**FRCR Consultation Response Proforma**

**FRCR Consultation**

Respondent details	Please enter your details
<b>Respondent name:</b>	Andrew Larkins
<b>Company name:</b>	Sygensys
<b>Email address:</b>	al@sygensys.com
<b>Phone number:</b>	07810750417

Figure 1 – Map of Hornsea, Little Barford and the Lightning Strike

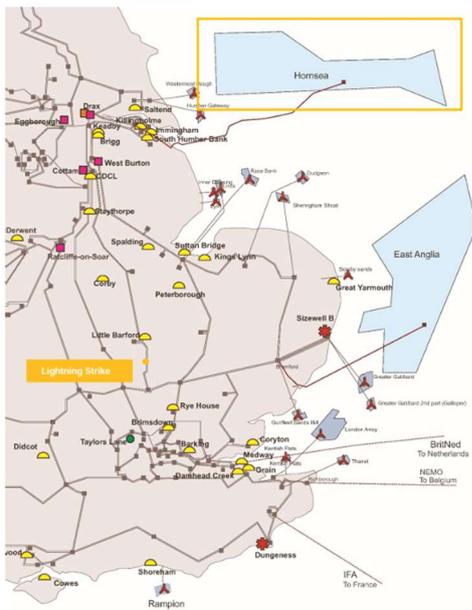
Including a map of the geographic extent of the impact would be useful in future event reports.

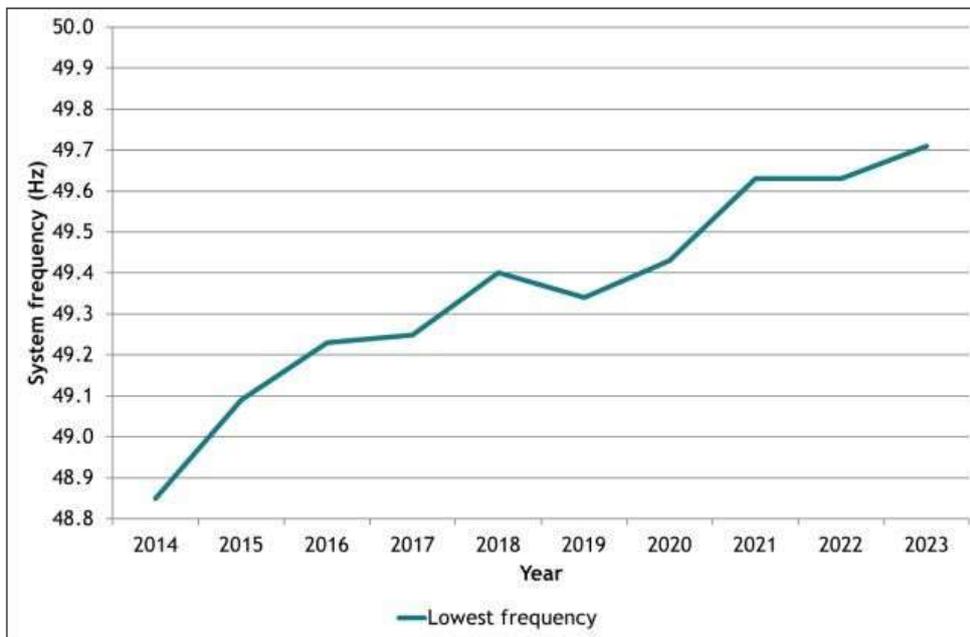
Question “Have you analysed events & trips reported under GC0105 to test your assumptions of trips, performance of the responses and probabilities of events?”

The brief answer suggests that fault statistics can be found in eGAMA but, having requested access via the Modelling & Insight team, I was told this data is not available publicly; using [REMIT | Insights Solution \(elexon.co.uk\)](https://www.elexon.co.uk) was suggested as an alternative. However, this does not distinguish sudden trips from controlled shutdowns for unplanned outage, and it does not provide exact timing of events to allow firm identification of sequence of events and cascades.

Answer "Event risk statistics are derived from two aspects: Generator trips that caused more than 250 MW power loss - fault statistics can be found in eGAMA for any fault/unplanned outages."

An OTF report extract is shown below.

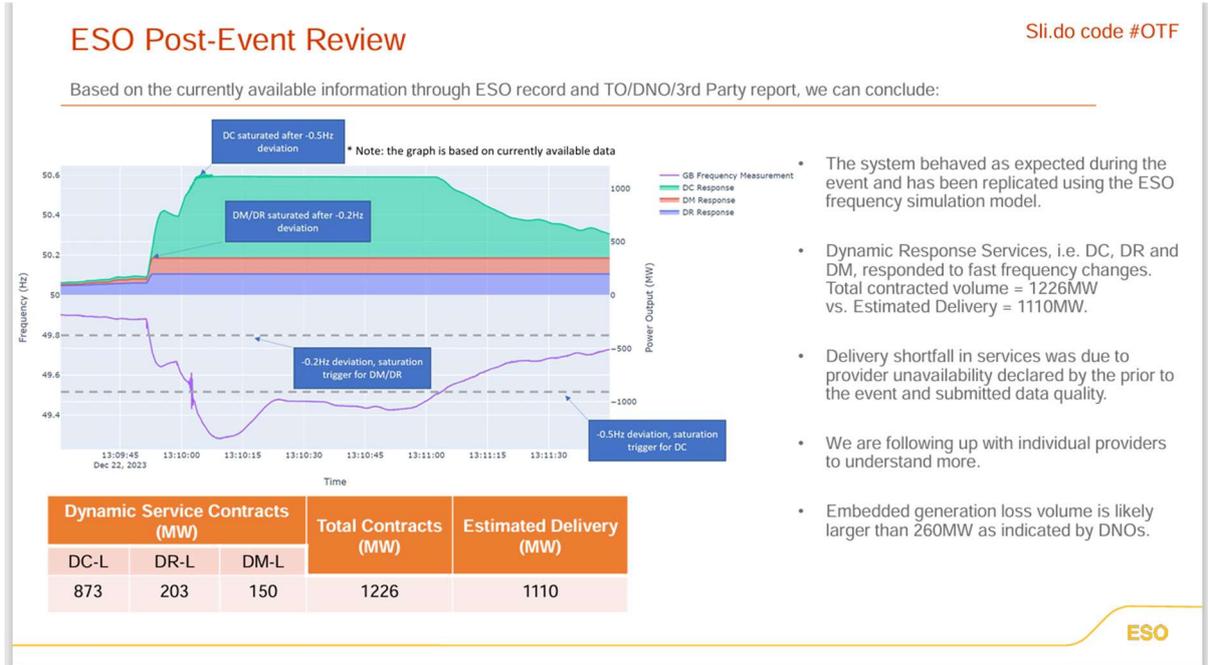
From the top right of the slide **“The system behaved as expected during the event and has been replicated using the ESO frequency simulation model.”**

This statement is potentially misleading and significantly downplays the seriousness of the event. Tripping of IFA1 should not have caused any other assets to trip, let alone the multiple stage cascade event that was seen on this occasion. The system therefore did not behave as expected.

I believe the statement could be revised to provide greater clarity: “The cascade series of events was not expected. However, given post-event knowledge of these trips and the related loss of infeed, the system frequency behaved as expected during the event and has been replicated using the ESO frequency simulation model.”

To identify the seriousness of the 22 December event, it is important to note from the OTF slide above that within 11 seconds of the start of the event, the frequency response services DM, DR and DC were all saturated. In other words, all of the fastest frequency reserves were fully used. The system was potentially at a cliff edge where frequency could have fallen very rapidly had the losses been a little larger.

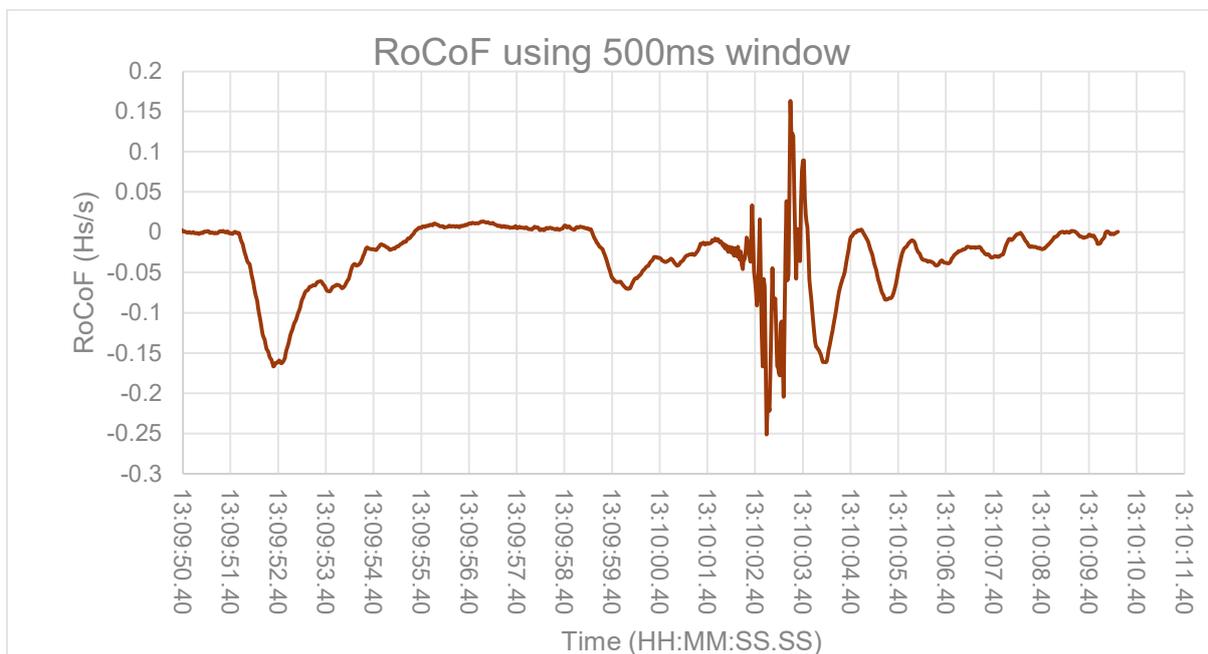
It should be noted for a reporting standpoint however that this figure is not given in the related [GC0151 and GC0105 System Incidents Report December 2023](#). See cell highlighted below.

From the GC0151 report above, the RoCoF is stated as between -0.152 (max) and -0.062 Hz/s (min). This may have triggered RoCoF anti-islanding protection if any generators remain with settings at 0.125 Hz/s. The Accelerated Loss of Mains Change Program should have dramatically reduced the number of plants impacted, so it is unlikely to account for all the observed embedded generation losses.

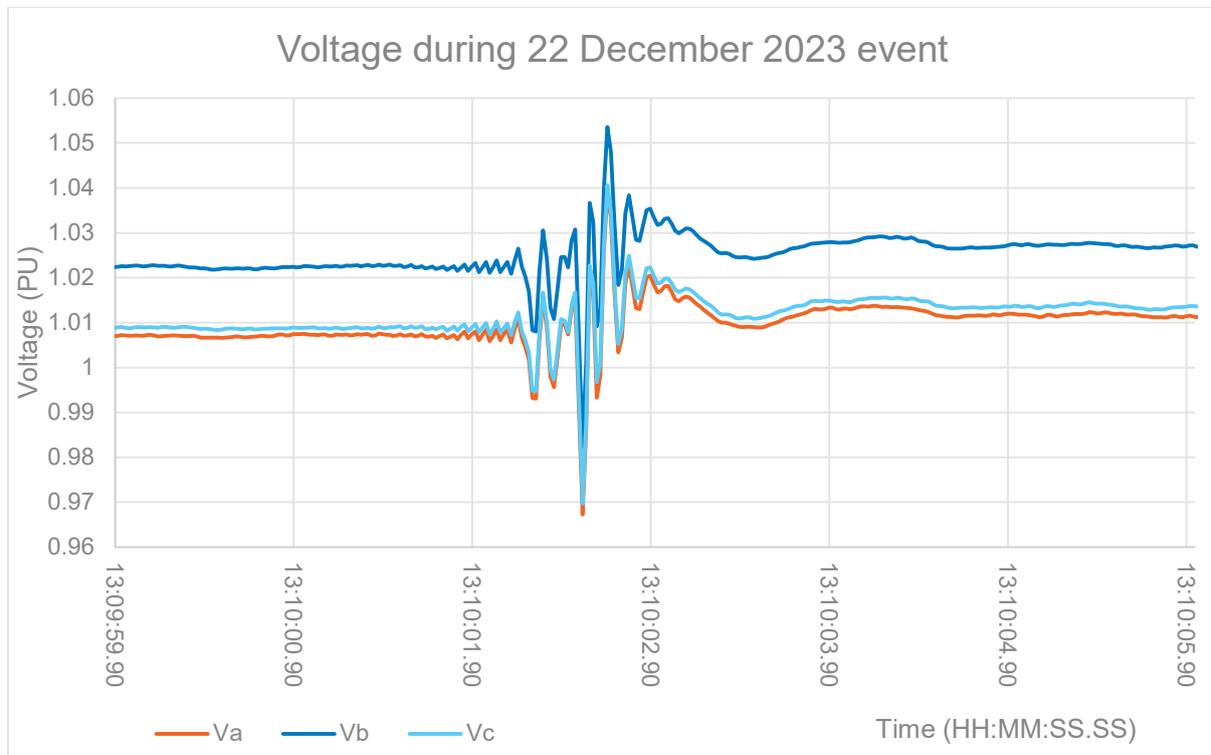
For reference, below is a PMU recording of the voltage at an LV location in the Central belt of Scotland during the 22 December 2023 event, expanded around the time of wide voltage deviations. This shows a moderate disturbance, remaining well within 0.9 to 1.1 PU, but it should be noted that this measurement was a significant distance from the assets which tripped.

Greater awareness of voltage disturbances during events will help in the analysis of FRT risks and may shed light on events such as the 22 December 2023 Caithness HVDC trip.

### **Vector Shift Withstand - Type B,C and D**

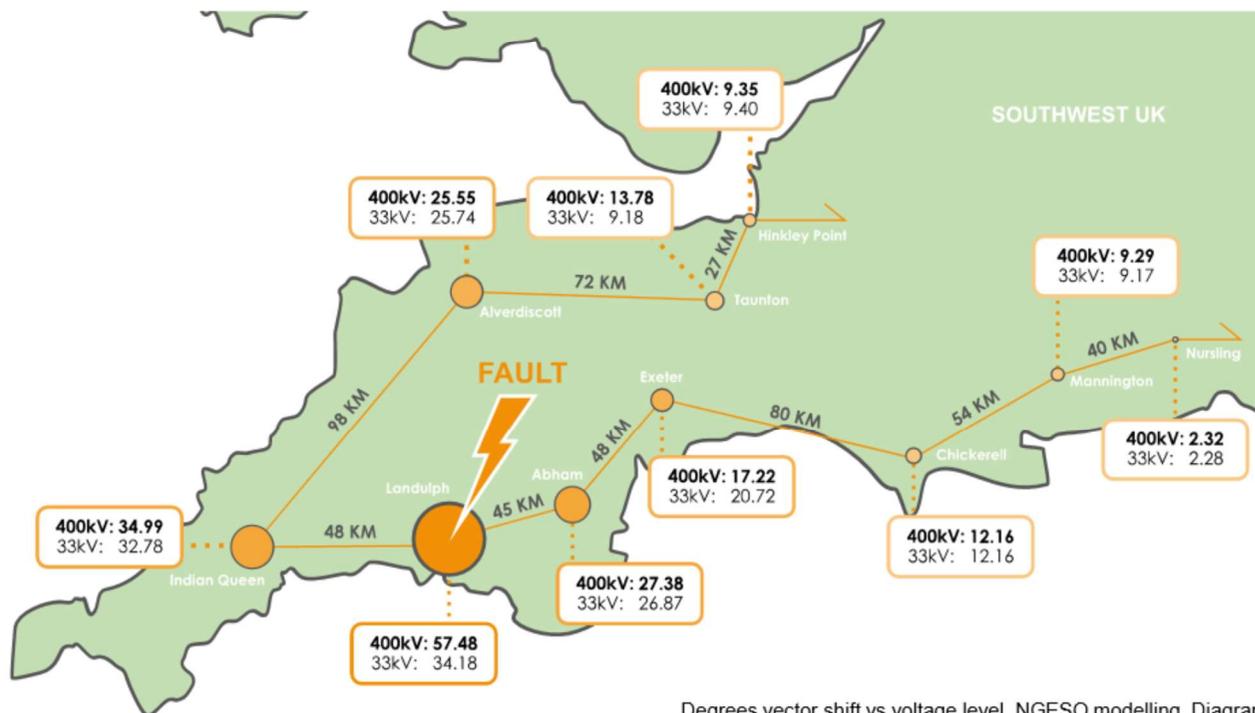
For positive or negative phase jump of 25 degrees and voltage in the range 0.5 to 1.1 PU the plant must remain connected and the Fast Fault Current Injection, as defined in ECC.6.3.16, shall be at least 90% of the level required when there is no phase jump.
